A585 Windy Harbour to Skippool Improvement Scheme

7.11 Environmental Statement Changes and Corrections Document

May 2019

Status	DEADLINE 2 SUBMISSION	Revision	1
Scale	1:2500 A3	Date	MAY 2019
Drawn By	J.NORMAN	Checked By	K.BURROWS
Approved By	N.HENDERSON		
PINS No.	TR010035	FIGURE	11.4
Drawing number	HE548643-ARC-EGN-SZ_ZZ_000-DR-LE-30

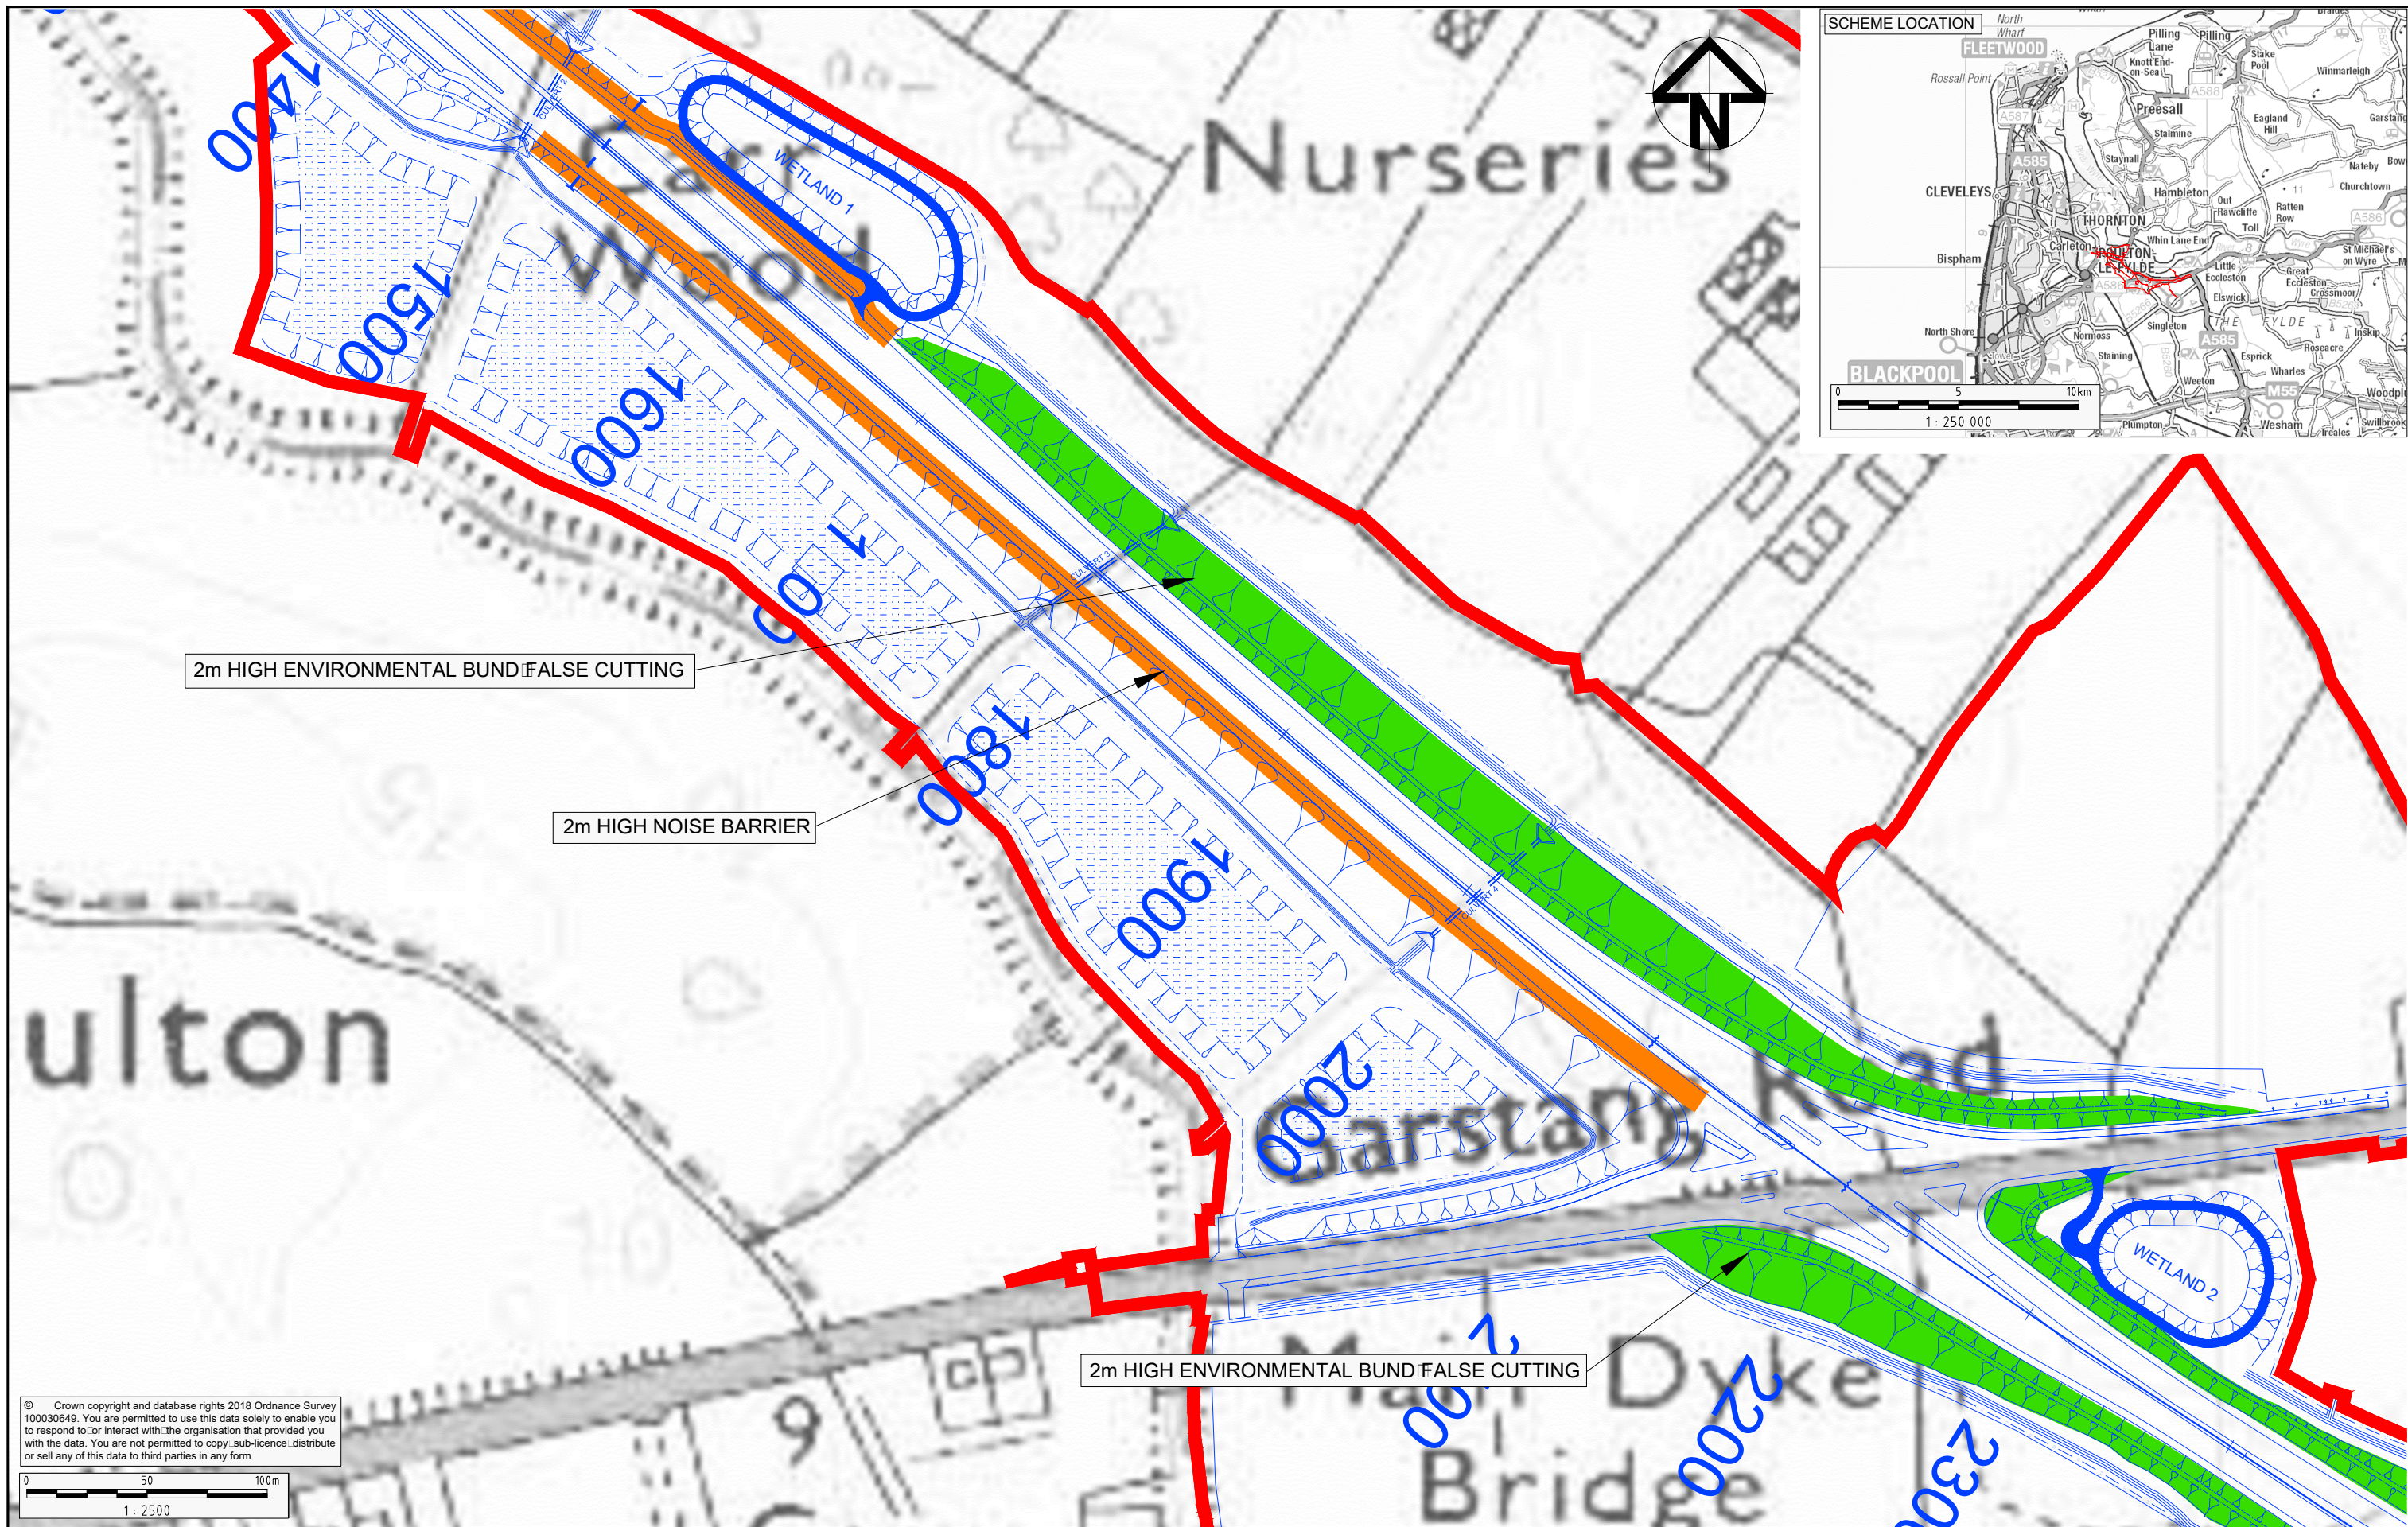
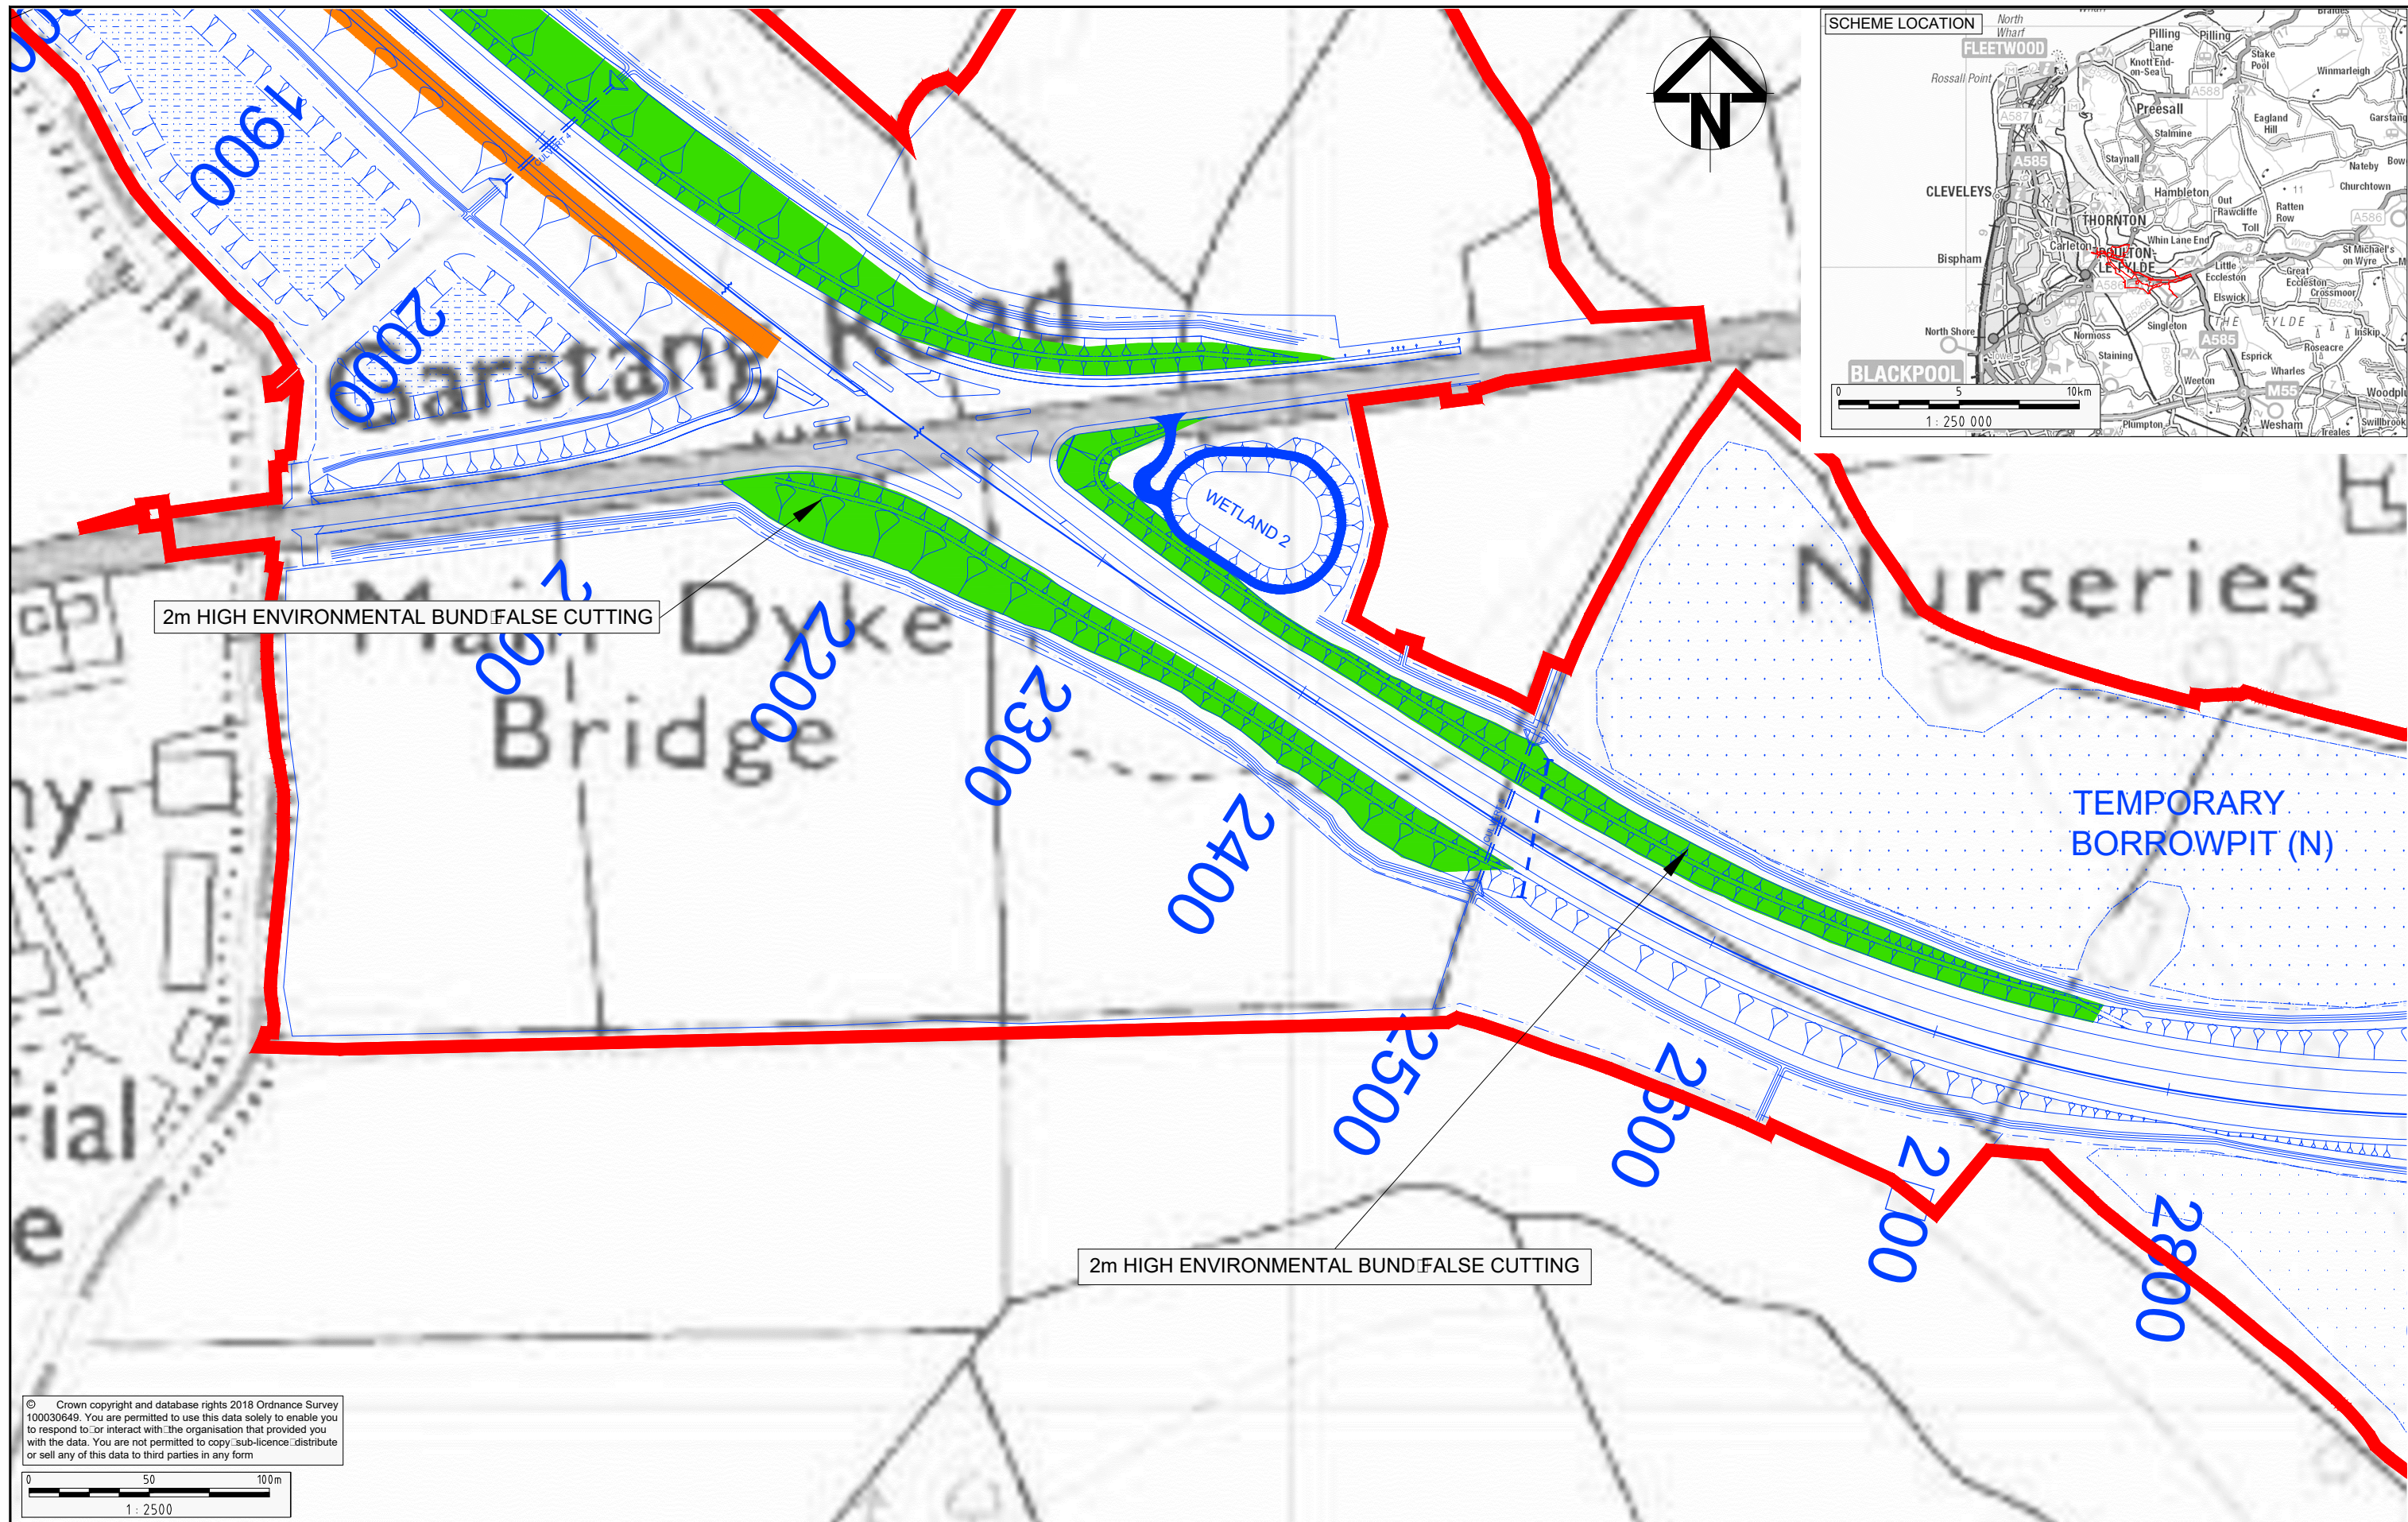
6.11	ES Chapter 11: Noise and Vibration	Update to Figure 11.4: Noise and Vibration – Noise Mitigation within the Study Area presented at Appendix D to show heights and locations of earth mounds and acoustic fencing at a larger scale.	Requested by the Inspector within the first round of written questions (document reference TR010035/APP/7.10).
